Fairhaven
City/Town

WPA Form 1- Request for Determination of Applicability

PROPOSED SITE PLAN
 6 EMERSON AVENUE
 FAIRHAVEN, MA
 FOR
 NATLIE REIS

PLAN OF SITE REMEDIATION
PREPARED FOR
MDC ESTATE, LLC
2 MELPEN WAY
FAIRHAVEN, MASS.

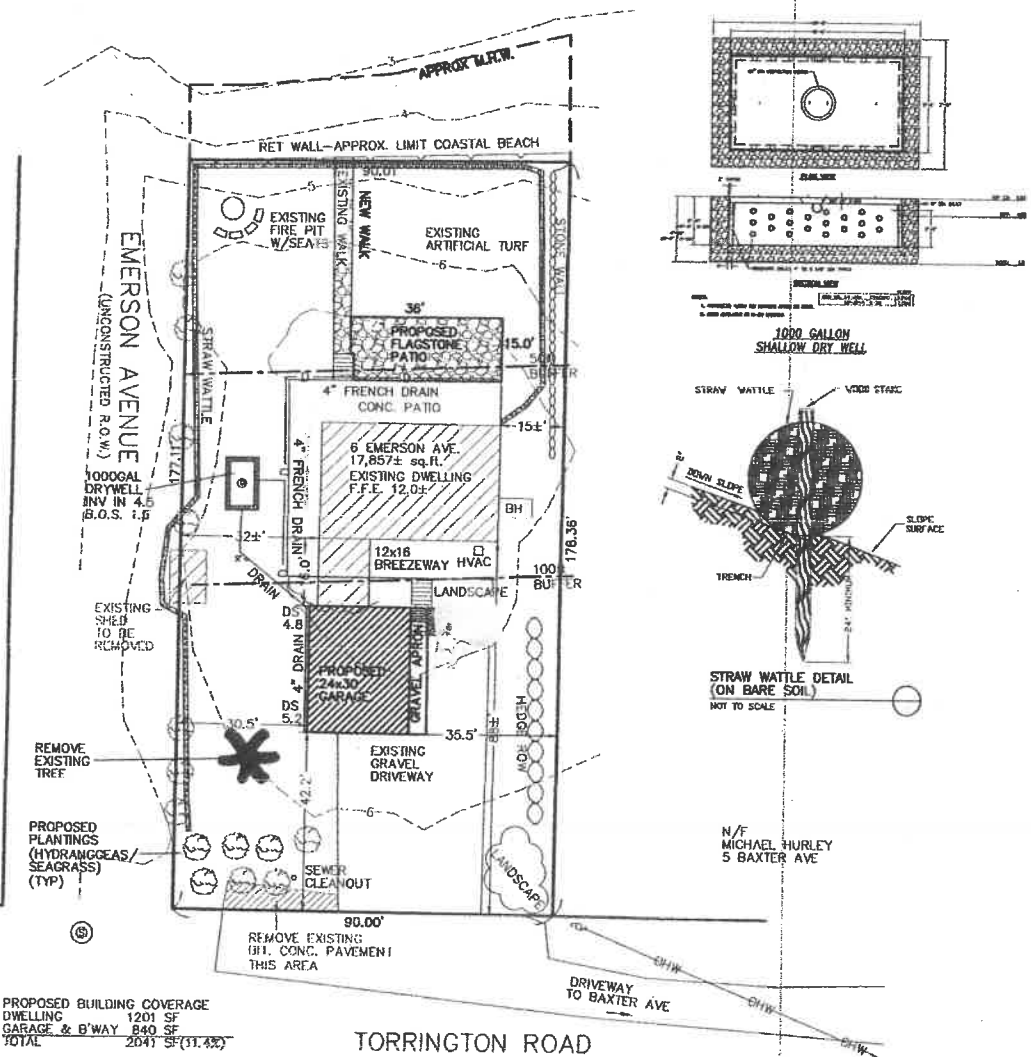
The proposed GARAGE has been Relocated. It has been moved from 5' from the Southern property line, to 30' from the Southern property line. The AREA it has been relocated to is also a higher elevation and is adjacent to the existing house.

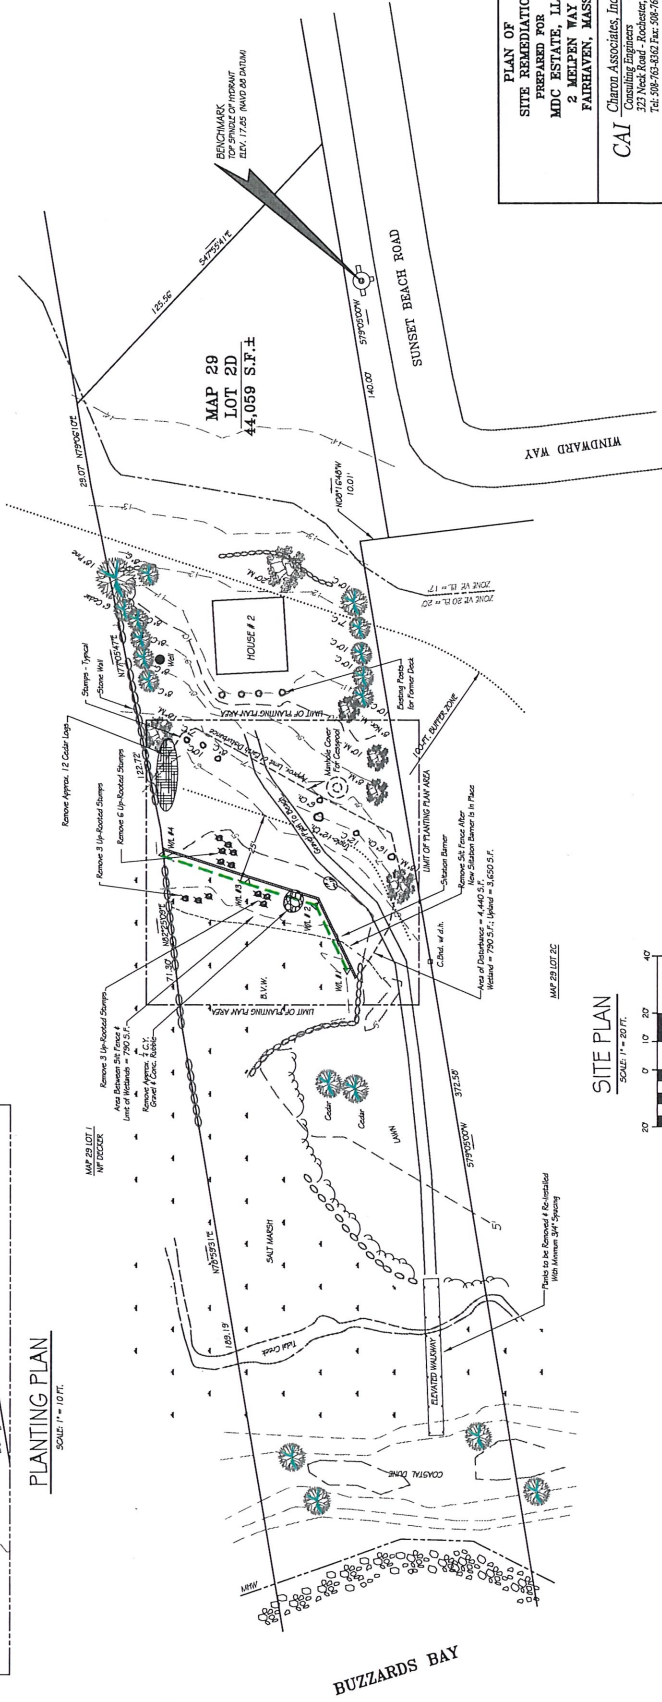
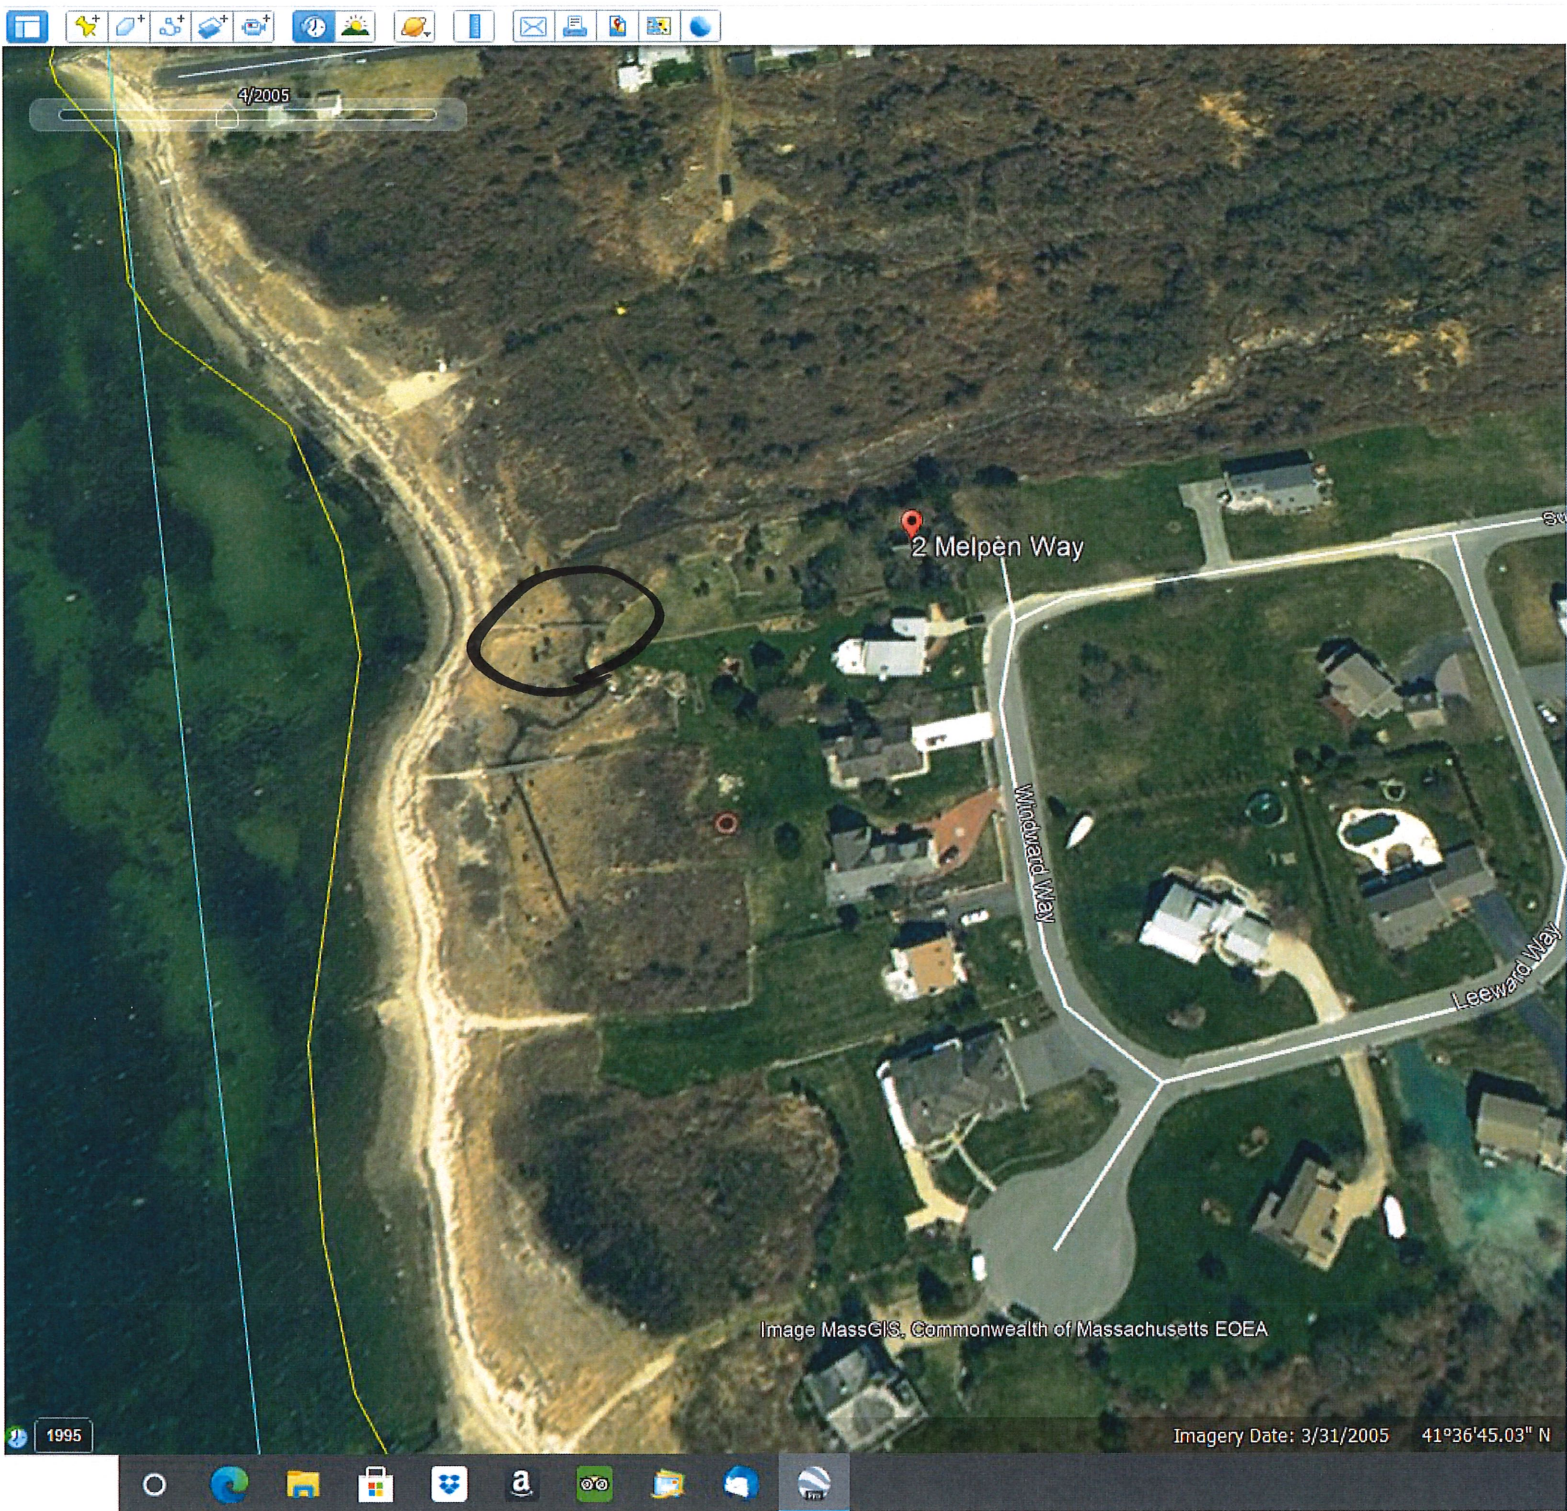
The Plan of Record (POR) is titled “*Plan of Site Remediation, prepared for MDC Estates, LLC, 2 Melpen Way, Fairhaven, MASS.*”, dated October 30, 2020 and has a scale of 1” = 20’. This plan depicts the “wetland boundary”, WL-1 to WL-4, the area of the unpermitted work labelled as “approximate limit of earth disturbance” and a 25’ wide buffer zone that is proposed as the “Restoration Area”.

Based on the guidance on plant spacing in the *Massachusetts Inland Wetland Replication Guidelines*, DEP 2002, Charon Associates Inc. has depicted on the POR proposed locations of tree saplings. The actual placement of the tree saplings will need to be discussed further with the FCC. It is planned to plant 19 tree saplings as noted on the POR to replace the 19 trees that were cut. Spacing will be at 8’ o.c. Within the 25’ buffer zone it is proposed to plant 30 shrubs in clusters.

In the EO reference is made about a “boardwalk across the marsh” and that the spacing of boards is incorrect. This boardwalk has existed in this location since on or before 2005 (See Google Earth photographs appended, 2005, 2010, 2013, 2014 and 2015). It is planned to re-plank this boardwalk so that the spacing between the boards will be at ¾” as stipulated on the POR.

Tree saplings should be planted according to the POR prepared by Charon Associates Inc. and/or at the discretion of the FCC. Each tree should be no smaller than 8'-10' in height and approximately 3-3.5" caliper (root ball 32-36" and a weight of 750-850 lbs.). The number of each sapling species proposed to be planted is shown below. Replacement tree saplings are proposed along the northern property line (stone wall).

Woody shrubs should be planted according to the POR prepared by Charon Associates Inc. and/or at the discretion of the FCC. Each shrub should be no smaller than 2-3' in height and planted in clusters of 3-5 shrubs. A total of 30 shrub species is proposed to be planted and the number of each species is depicted below.
